Submission of Further Information (FI)

**Temporary Animal Boarding Establishment with Ancillary Facilities and associated
Filling of Land for a period of 5 years in "Agriculture" Zone,
Lot Nos. 1493 (Part) and 1500 (Part) in D. D. 107 and Adjoining
Government Land, Yuen Long, New Territories
(Application No. A/YL-KTN/1177)**

Further Information for Planning Application No. A/YL-KTN/1177**Response-to-Comments****Comments from Drainage Services Department**

- END -

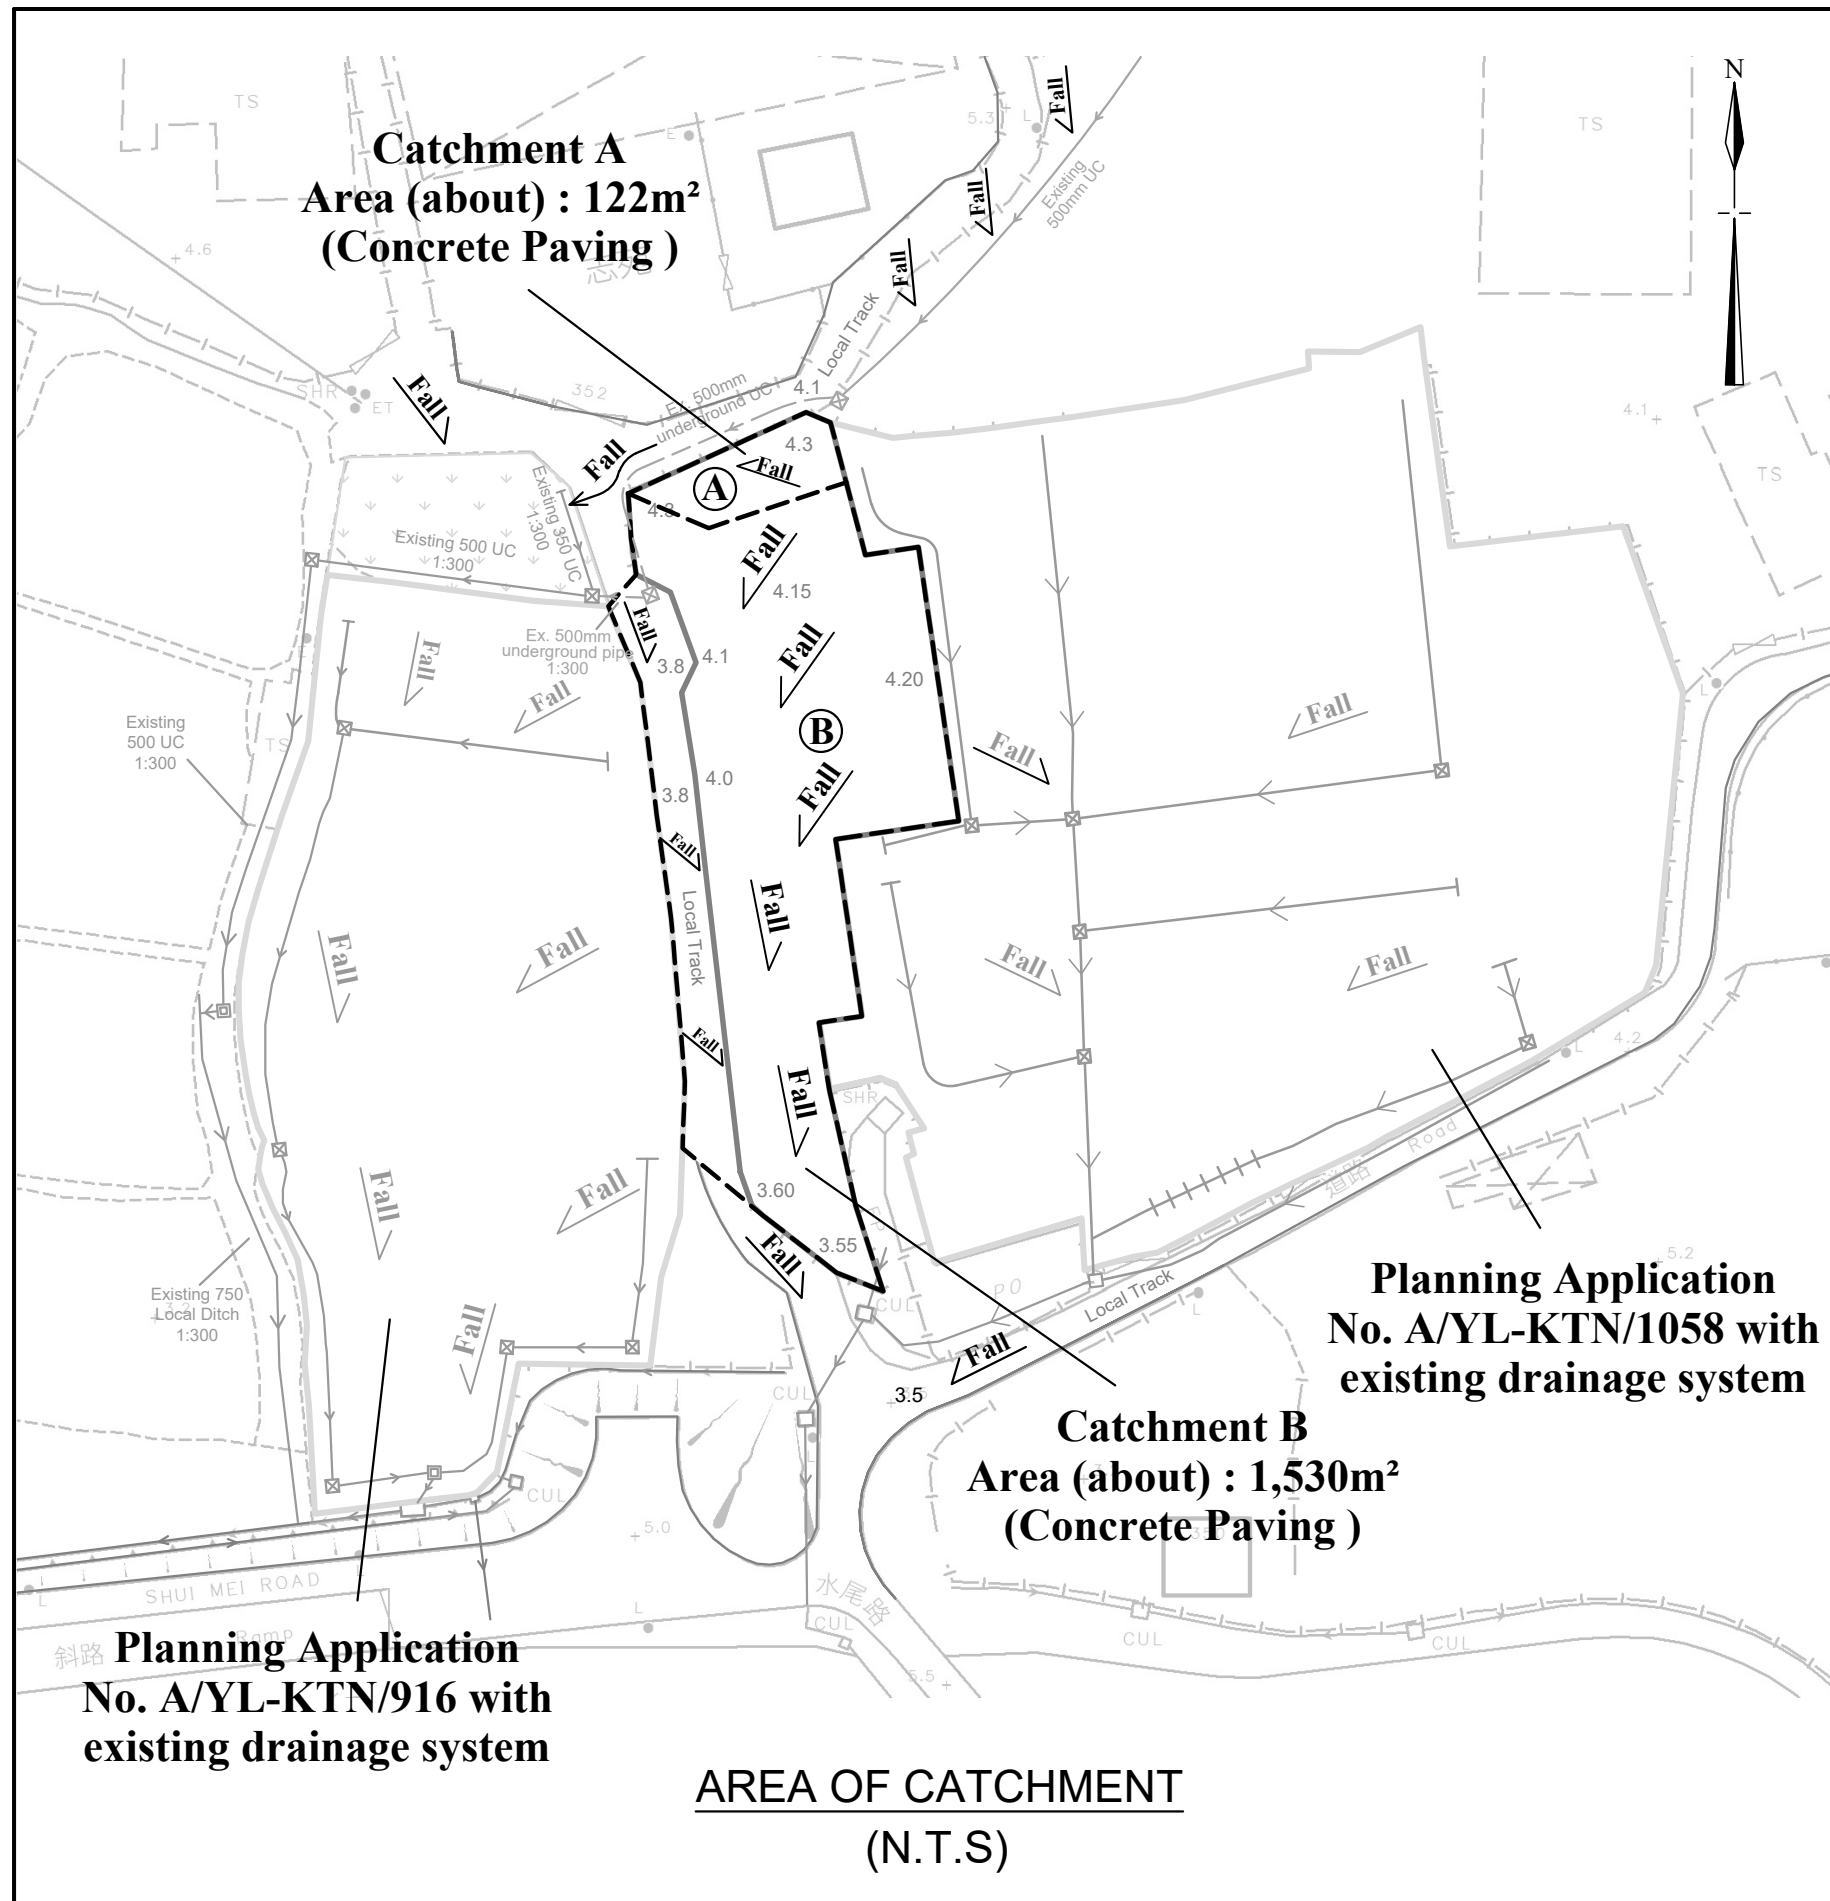
I.	Comments	Responses
1.	Sections - Please indicate the hoarding opening in drawings.	Hoarding with opening is provided at the western side of the site. Please refer to updated Drainage Proposal (Plan 6.1b) for details.
2.	Section B - Please review the adjacent site ground levels. According to our record, the adjacent road level is higher than the application site, external catchment area should be considered. Please update the section and calculations if necessary.	Portion of the adjacent road at the west is at a higher level than the site. External catchment area is included. Please refer to updated Drainage Proposal (Plan 6.1b and Plan 6.2b) and Hydraulic Calculations for details.

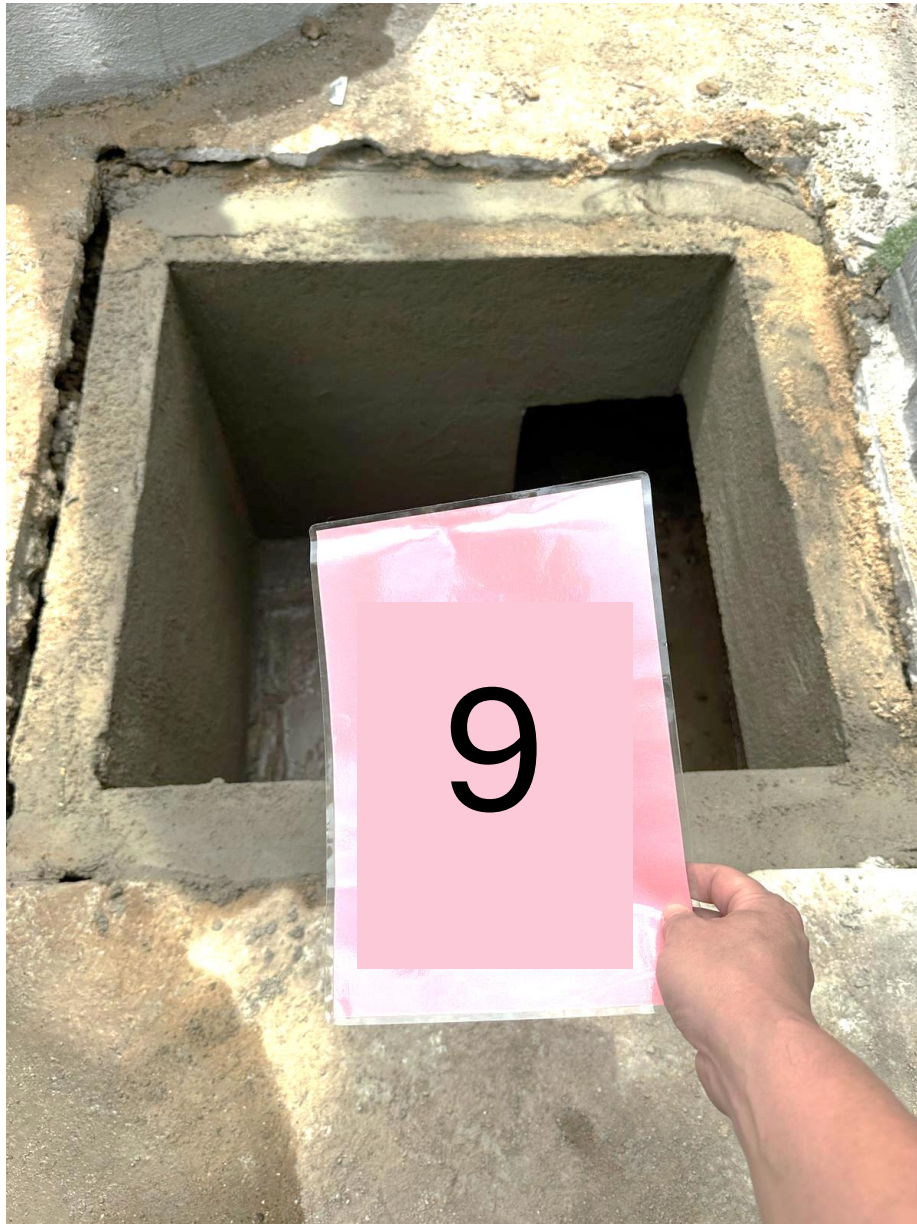
The ground level of the Site has been higher than the local track for many years. The surface runoff from the local track will not flow to the Site.

Existing gutter which collects runoff from the roof to avoid runoff falls to the local track at the north.

Opening has been provided
along hoardings.
